I am writing with great concern about the plan to expand the School of Human Ecology at the University of Wisconsin-Madison. I am a faculty member in the Folklore Program (College of Letters and Sciences) and the Department of Landscape Architecture, where I teach courses on cultural landscapes and preservation and use campus landscapes as examples and laboratory settings. I count several Human Ecology faculty as close colleagues, enjoy student design and other programming in Human Ecology's Design Gallery, and have been looking forward to enhanced exhibit and textile collections spaces. But my students, project assistants, and I are regular inhabitants of Agricultural Hall, where our work spaces lie in the basement, on the east side of the building that will be most affected by the proposed expansion.

Subject: Comments on cultural landscape impacts of SoHE project proposal

I am sorry that my schedule does not permit me to attend this meeting in person. I appreciate the opportunity to provide the following written summary of my comments regarding the proposed School of Human Ecology (SoHE) Project for the UW-Madison campus.

OPEN SPACE SYSTEMS AT UW-MADISON

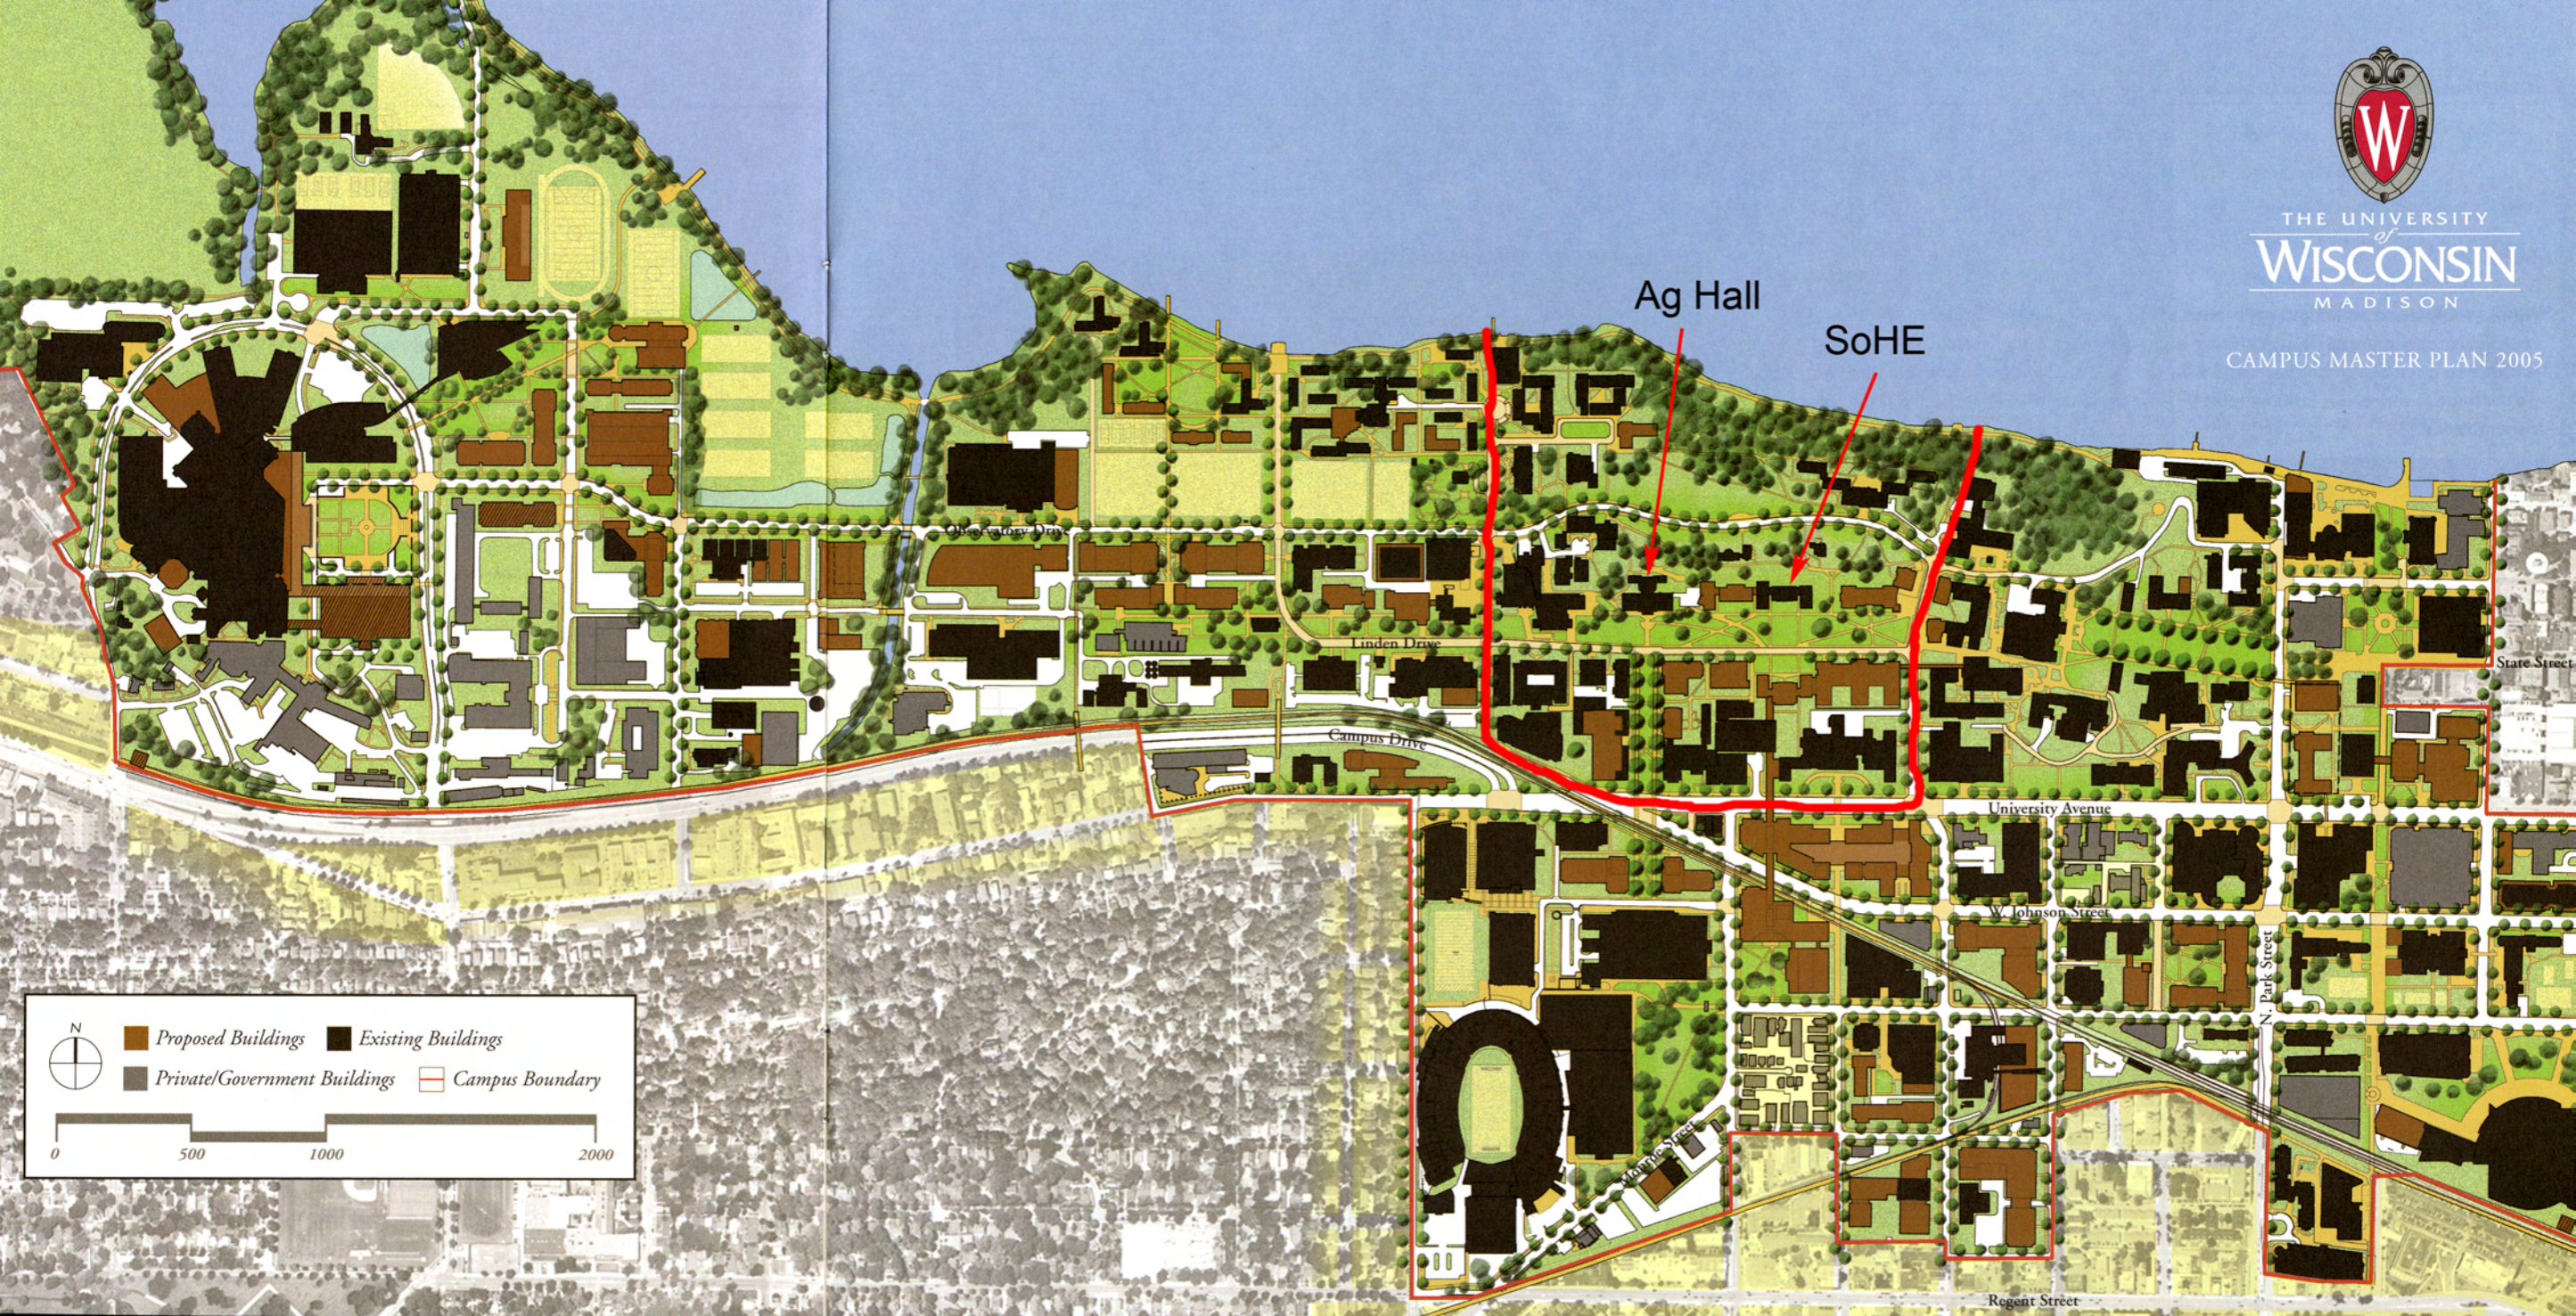
Priorities for Planning and Development: “Redevelop the Linden Drive corridor, re-establishing the ‘**Greater Mall**’ **open space concept and pedestrian features**.” (Note: refer to #13 on “Open Space Systems at UW-Madison.”)
